**EPA Superfund
Record of Decision:**

**SAVANNAH RIVER SITE (USDOE)
EPA ID: SC1890008989
OU 32
AIKEN, SC
06/18/1996**

**Interim Record of Decision
Remedial Alternative Selection
for the Old Radioactive Waste
Burial Ground (643-E) (U)**

WSRC-RP-96-102

Figure 1. Location of the Burial Ground Complex at the Savannah River Site.

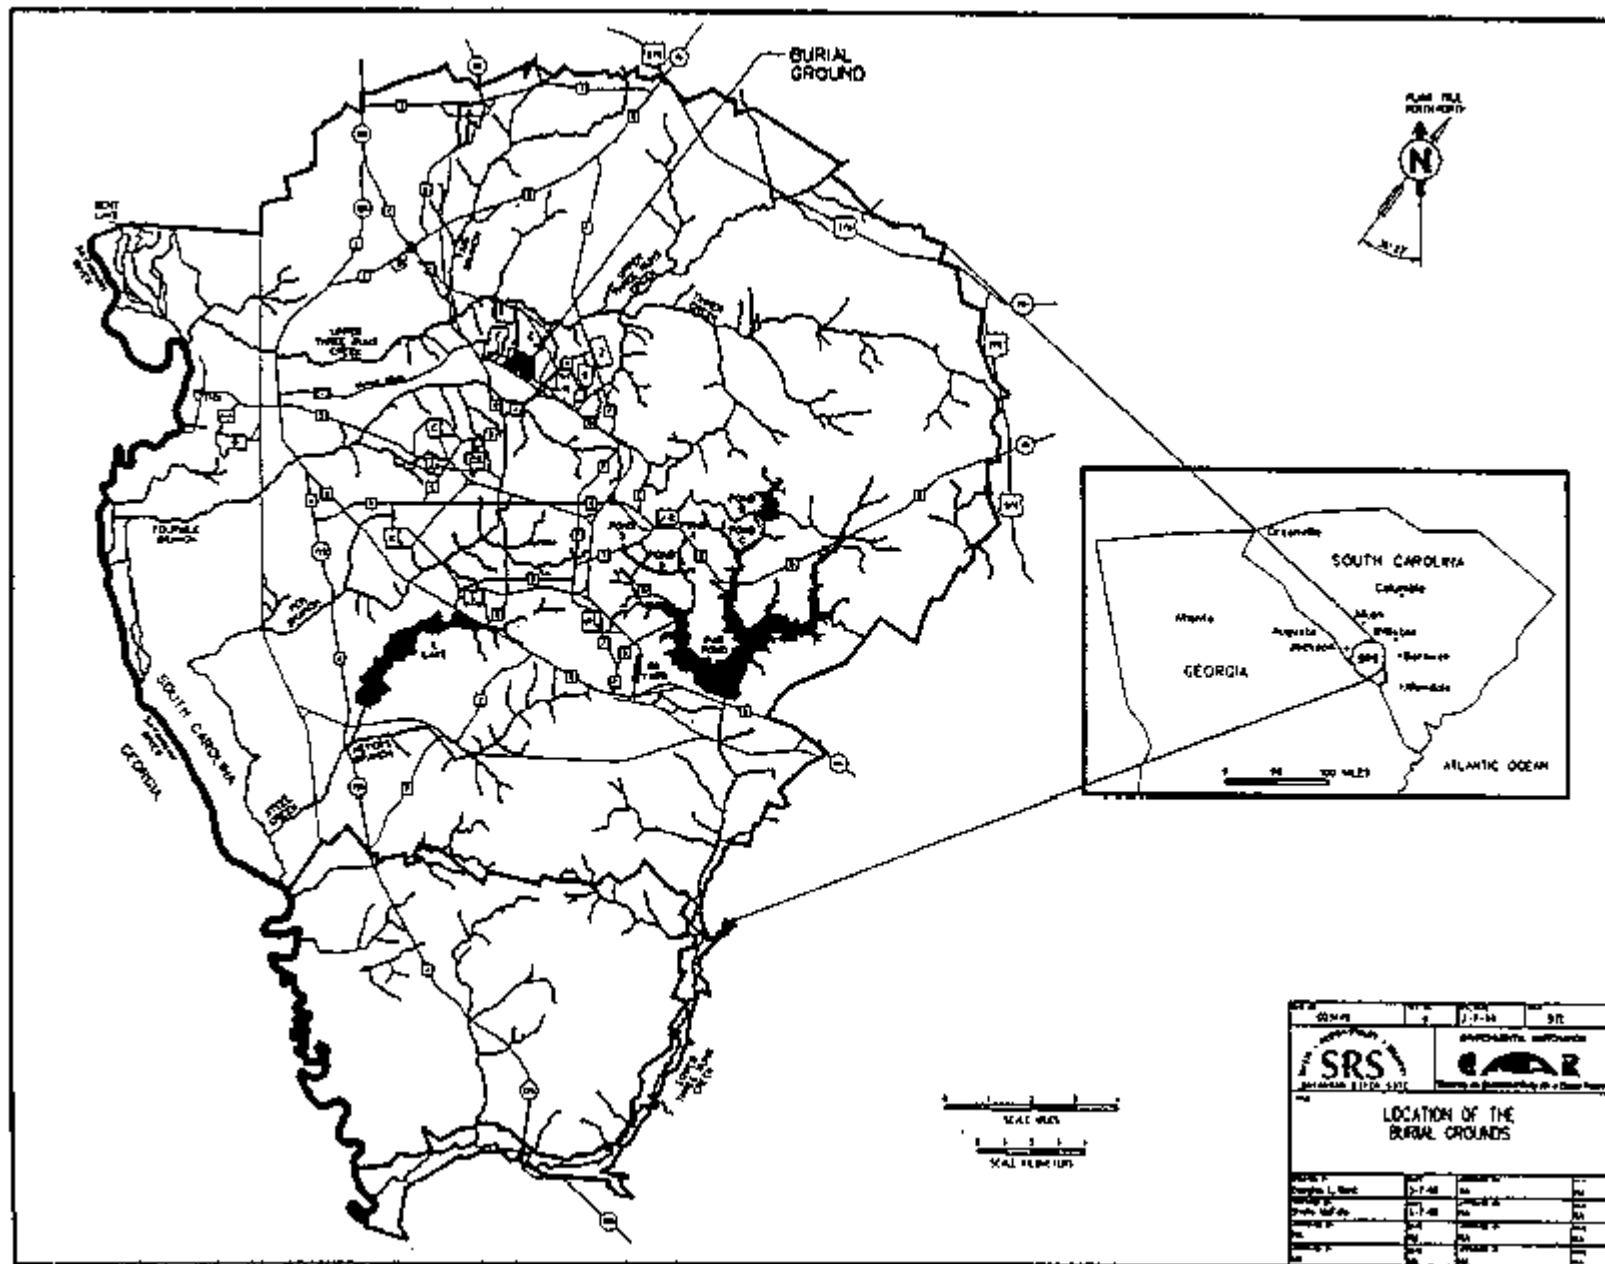
- S-1) *In Figure 1, the Burial Ground arrow points to a blank part of the Site. I know where the burial ground is located but others will not.*

Figure 1 was revised to better show the location of the Burial Ground.

Figure 3. General Locations of Disposal Sections in the Old Radioactive Waste Burial Ground

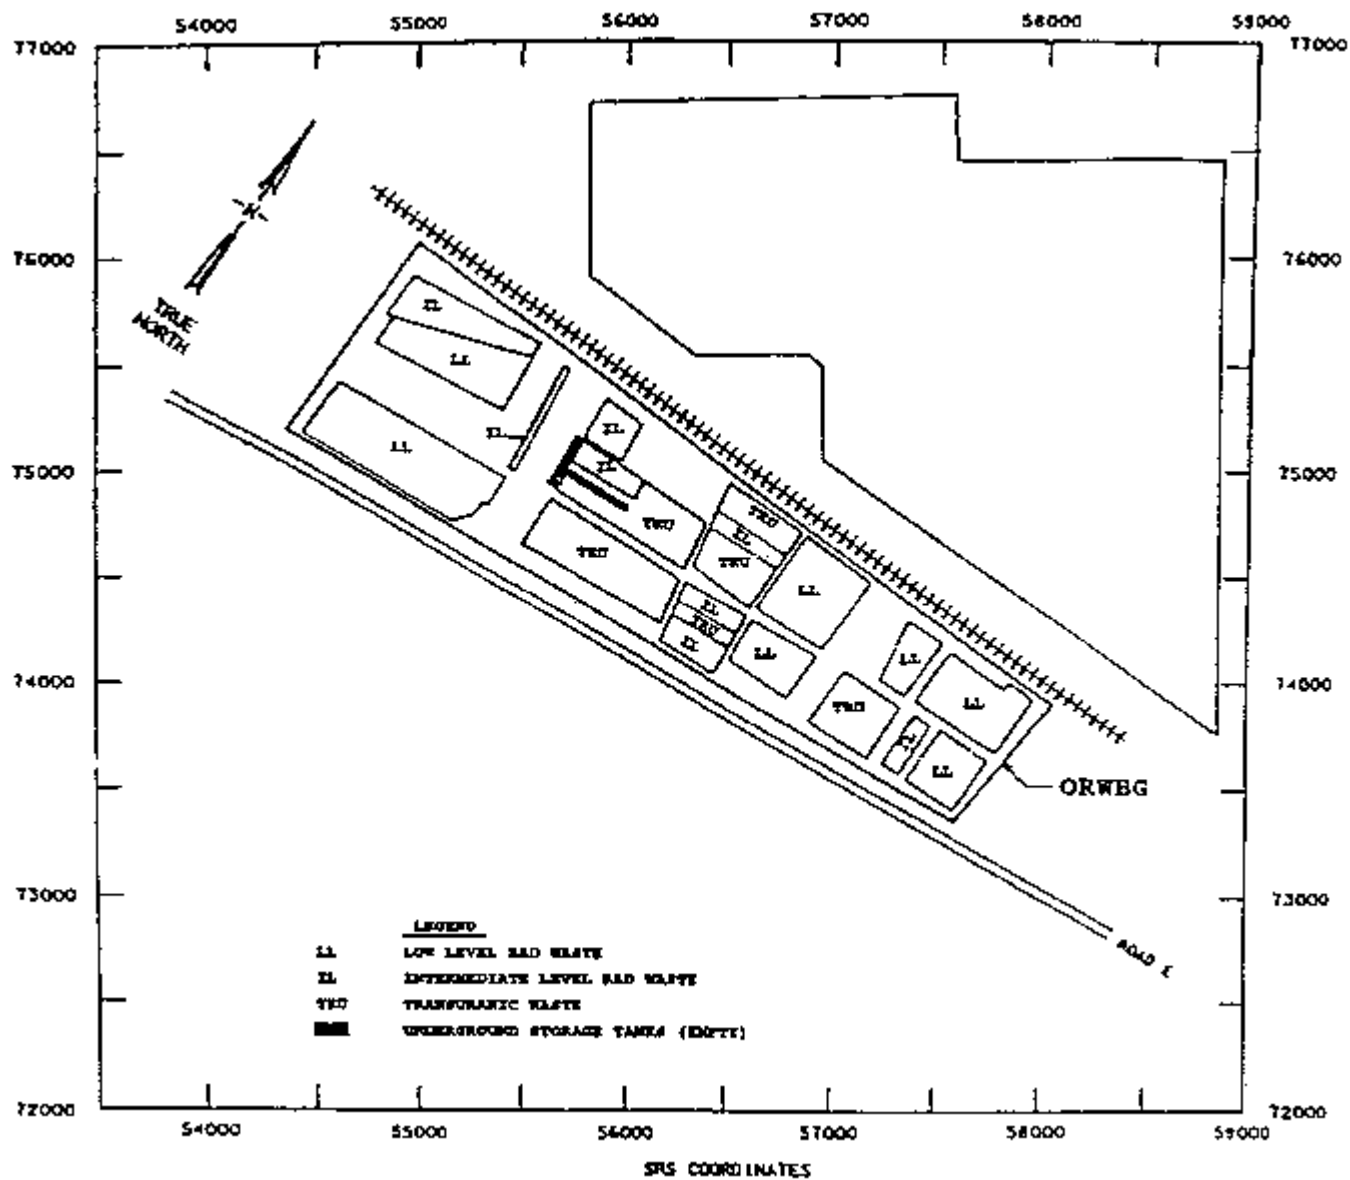
- S-4) *Figure 3 needs to be improved to show the relevance for this Interim Action for the ORWBG. The text says this figure shows the CERCLA activities. I couldn't see any CERCLA on the figure. The text and the figure do not support each other.*

The referenced figure was improved for inclusion in the Irod for the ORWBG. Additional headers were added to designate RCRA and CERCLA (FFA) activities. The purpose of the figure is to show all of the RCRA and CERCLA (FFA) activities at the Burial Ground Complex and their relative timeframe.
